TO: T10 Membership
FROM: Paul A. Suhler, Certance
DATE: 12 February 2004
SUBJECT: T10/04-053r0, Revision of ADT Error Recovery Ladder Diagrams

T10/369r3 has changed the error recovery state machines. This proposal updates ADT Revision 10 Annex B to change the state names and certain transitions to match the new state machines. It also adds a ninth diagram to illustrate the new TE2:Retry Initiate Recovery state..

Figure A.1 – Receiver-detected retryable error

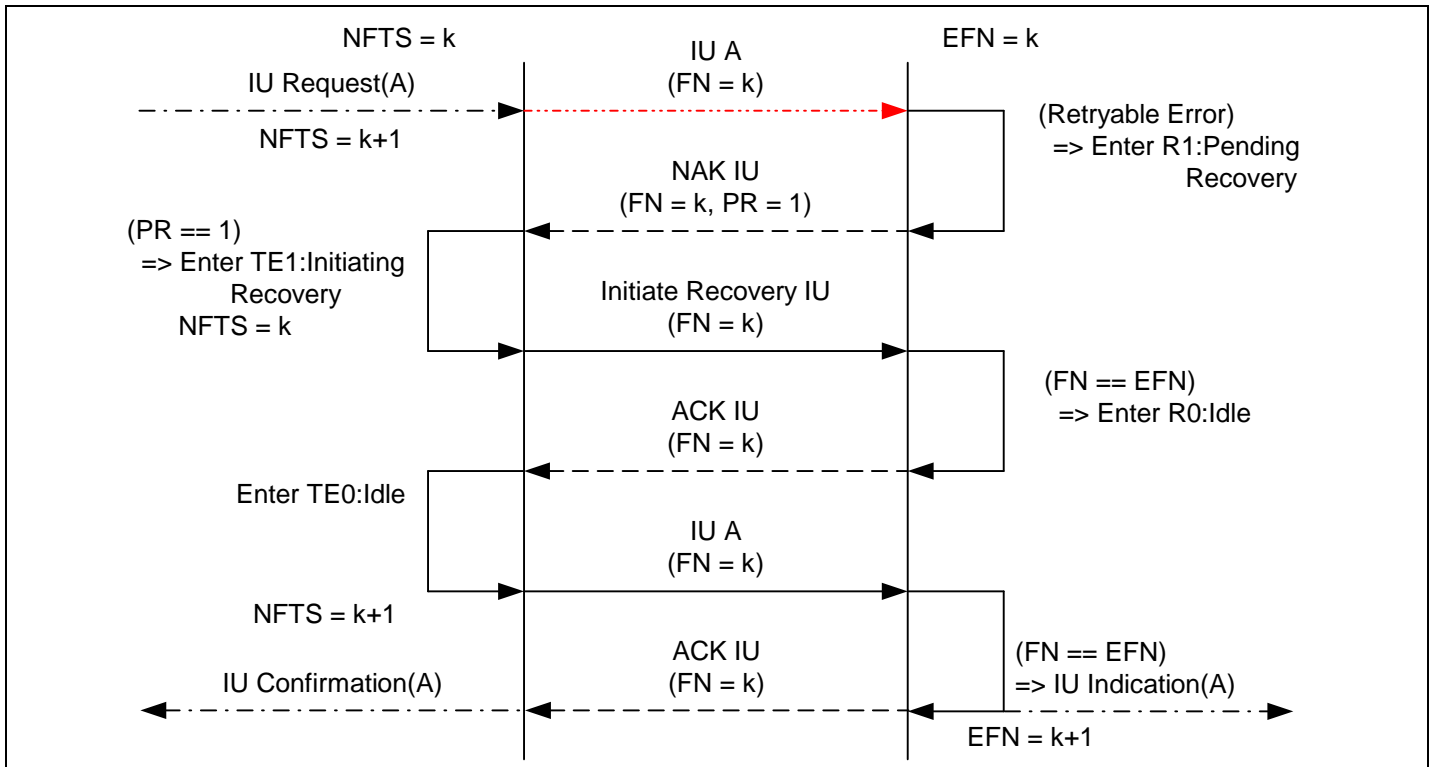
All sub-clauses of the Annex are changed, except for Non-retryable error (Figure A.7). It is included here for simplicity.
